140R6026Q0102 – Amendment 0001 - Attachment A

MTE Mobile Crane Support Service

U.S. Department of the Interior
Bureau of Reclamation
Missouri Basin Region
Billings, MT

MTE Mobile Crane Support Service
Amendment 0001 – 140R6026Q0102
Attachment A
Questions and Answers

DENVER, COLORADO, FEB. 4, 1971 — 382-D-978

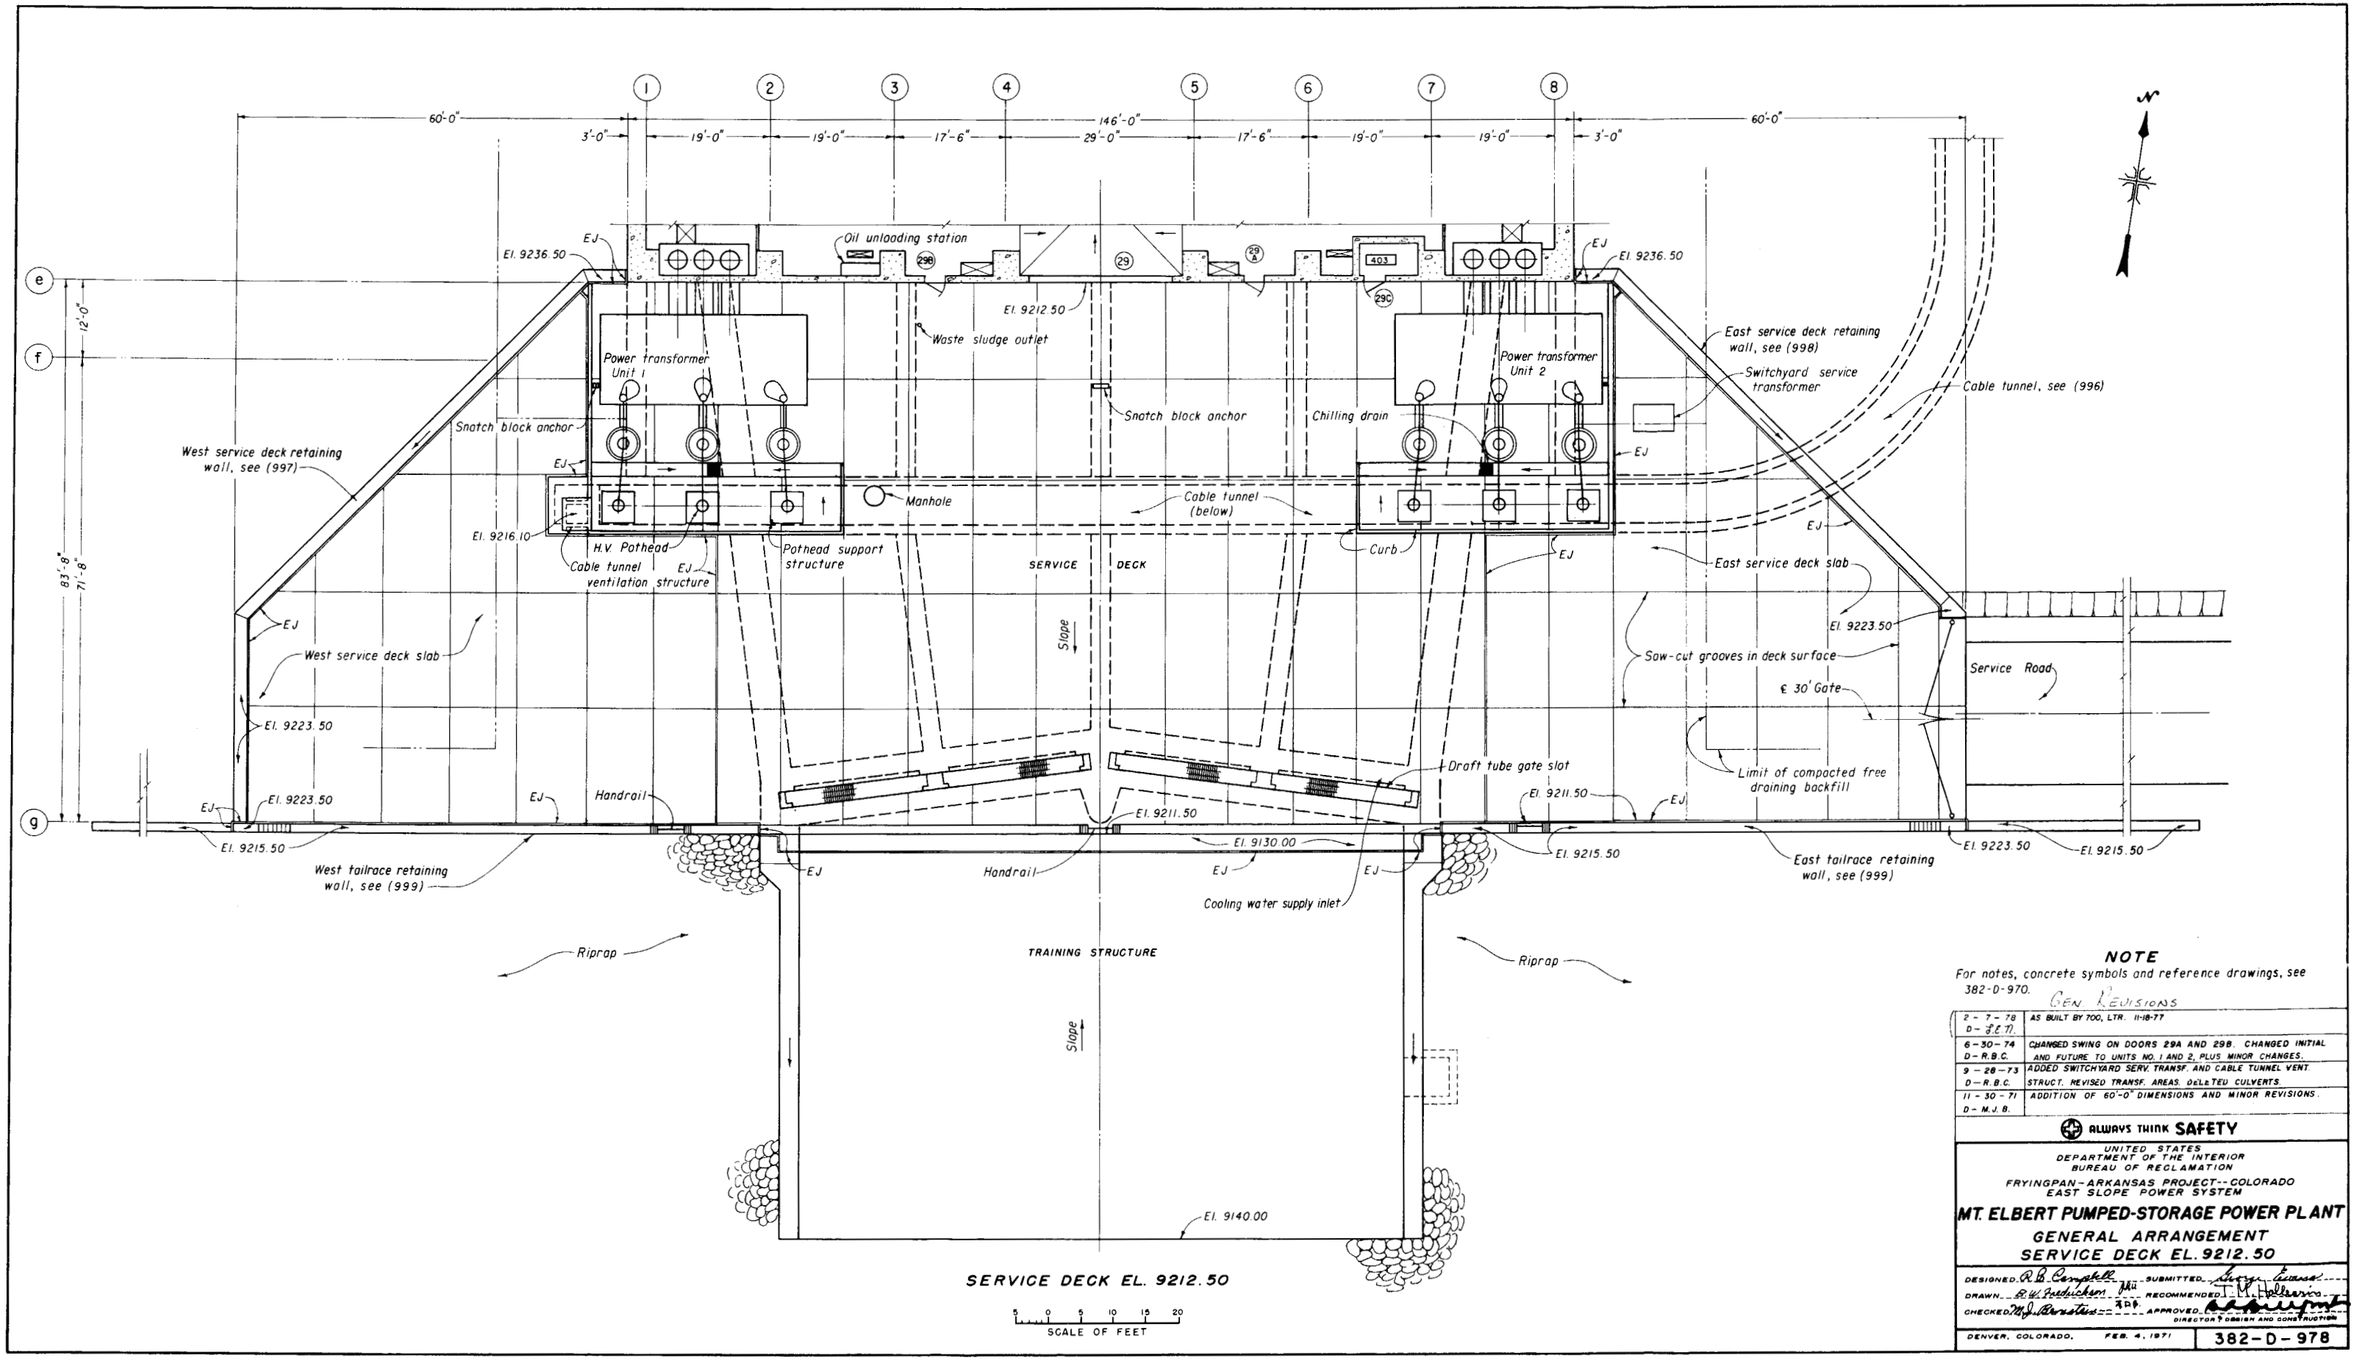
Q4. Are drawings or photographs available showing the lifting points, lift lugs, or designed lifting method for each concrete test block?

A4. See provided photographs. (382-D-972; 382-D-976; 382-D-978; IMG_1117; IMG_1118)
